RE: McMahon Market Place
Amended Drainage Management Plan
Stamp Date: 7/21/17
Hydrology File: A11D011G

RE: McMahon Market Place AMENDED DRAINAGE MANAGEMENT PLAN – DRB 1005280

MCMAHON MARKET PLACE
5708 MCMAHON BLVD NW
ALBUQUERQUE, NM 87114
AMENDED DRAINAGE MANAGEMENT PLAN

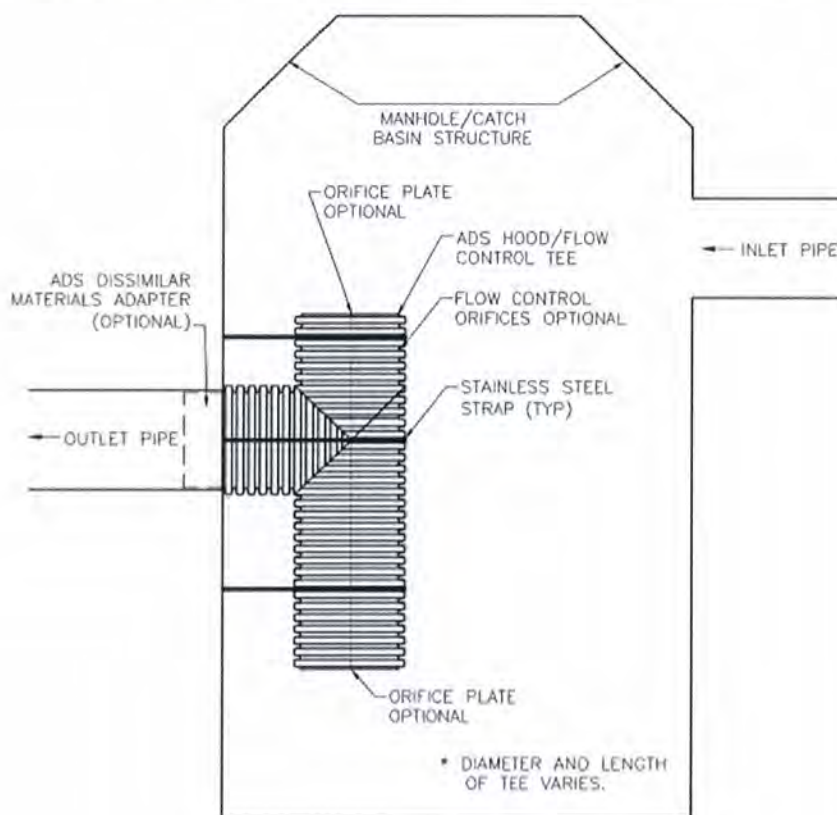
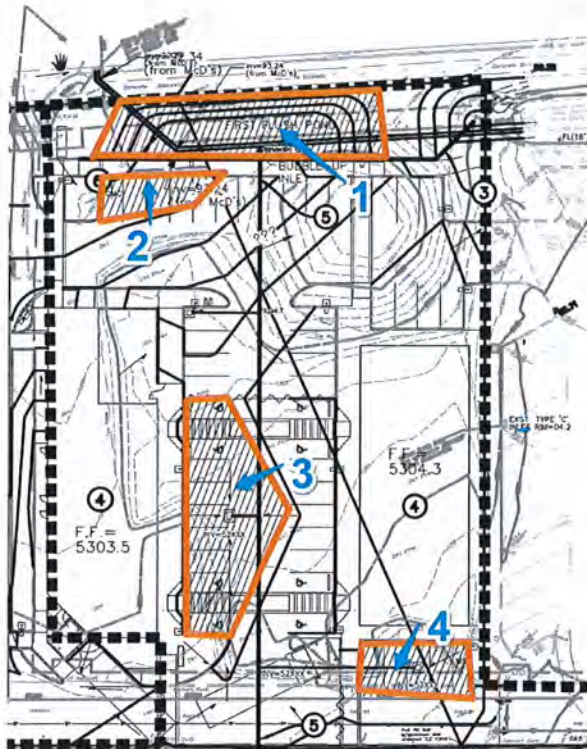
1. Duplicate information removed.
2. Duplicate information removed.
3. Information relocated on sheet.
4. First Flush Retention note revised.
5. Required detention equation corrected.
6. Drainage Concept updated to show required detention for Lots 5&6A and Lot 9.
7. Detention control will be achieved using at inlets using orifice control which will permit the asphalt parking areas to act as temporary ponding. See additional calculations on the following page.
8. See response to # 7.
9. See exhibit below.

Lot 5 and 6A = 1.75 acres: Required detention = 30% of total = 1.9 cfs

NOTE: Lot 5 and 6A will provide more than 1.9 cfs if possible to reduce the requirement for Lot 9 (same owner). Detention volume required ≈ 3,200 cf.

Detention will be provided using orifice control at drain inlets and at the connection to the existing private storm sewer connection to the public McMahon Blvd. system.

POND 1		
Contour	Area	Volume
5302.80	2787	
5302.00	0	1115 CF
TOTAL VOL.		1115 CF
POND 2		
Contour	Area	Volume
5298.70	491	
5298.00	0	172 CF
TOTAL VOL.		172 CF
POND 3		
Contour	Area	Volume
5297.00	2750	
5294.00	1200	5925 CF
TOTAL VOL.		5925 CF
POND 4		
Contour	Area	Volume
5303.60	956	
5303.00	0	287 CF
TOTAL VOL.		287 CF

Total volume available = 7,500 cf. Pond 1 will utilize approx. 1250 cf for first flush with the remainder available for detention.
